THIRD PROTEST UNDER 37 CFR 1.291(c)(5)
Against Pending U.S. Patent Application Serial No. 11/443,617

SERIAL NUMBER: 11/443,617

TITLE: Footwear with Separable
Upper and Sole Structure

EXPLANATION FOR THIRD PROTEST

FIG. 492 is an exploded longitudinal cross-sectional side view of the article of footwear 22 shown in FIG 491.

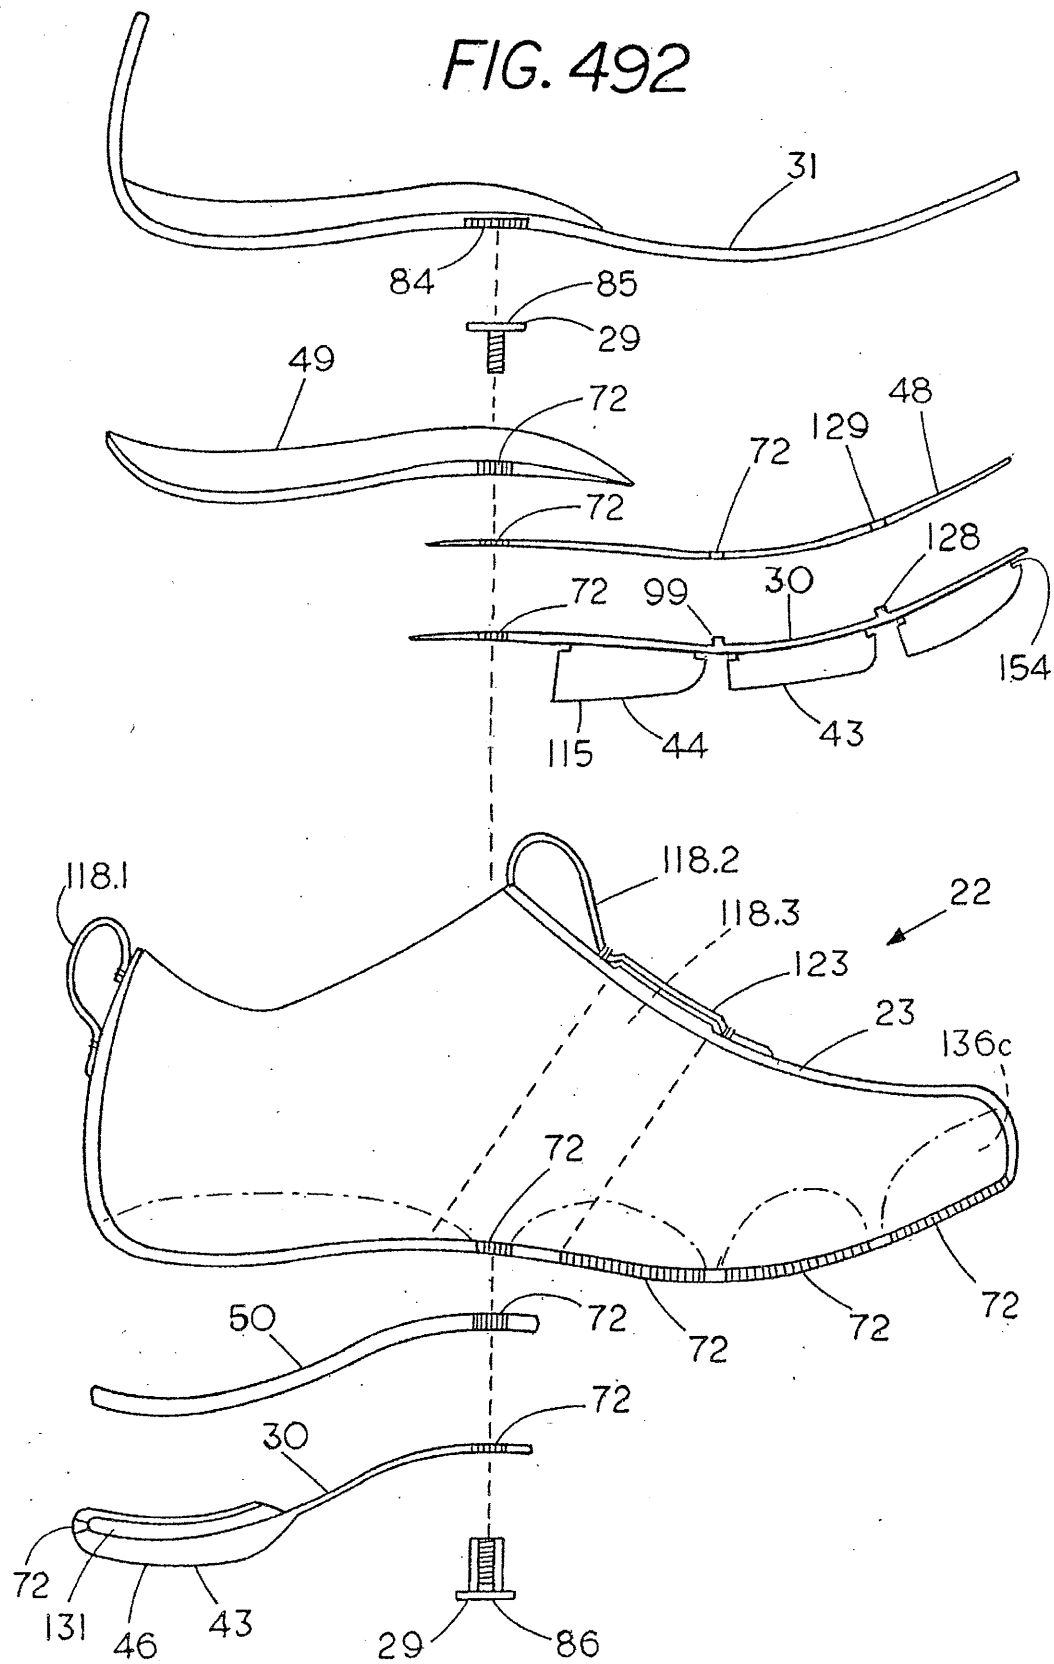
Figures 491 and 492 of U.S. 7,107,235 show and teach this structure and method of assembling an article of footwear for a wearer. In particular, the “undercut(s) 154” or indentations present in the protruding “traction member(s) 115” of the “sole 43” are shown in Figure 492 below.

FIG. 491 is a longitudinal cross-sectional view of an article of footwear 22 including an anterior outsole element 44 having traction members 115 including an undercut 154 portion. **The individual traction members 115 can include an undercut 154 portion about their perimeter that matches the size of the corresponding registered openings 72 which are present in the upper 23. Accordingly, the traction members 115 can overlap and effectively seal the openings 72, and the anterior outsole element 44 can be snap-fitted and mechanically locked in place when the traction members 115 of the anterior outsole element 44 are properly inserted through the upper 23.**

FIG. 254

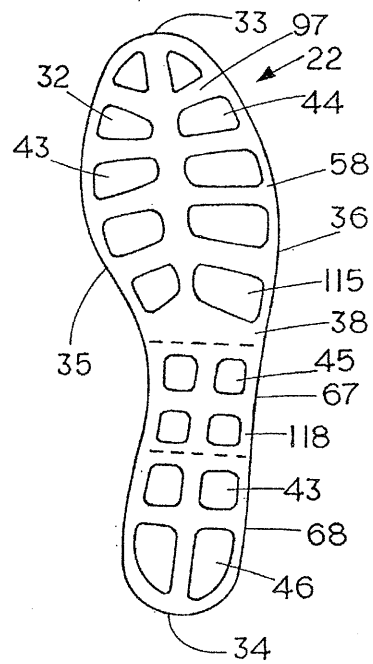
Further, U.S. 7,107,235 also teaches a footwear upper having openings or “apertures” and a removable sole which can extend full length relative to a footwear upper, as shown in Figures 254-255 (provided below), and also Figures 258-260. Accordingly, the structure and also the method of assembling and customizing an article of footwear recited in the claims of U.S. patent application serial number 11/443,617 are anticipated by U.S. 7,107,235.
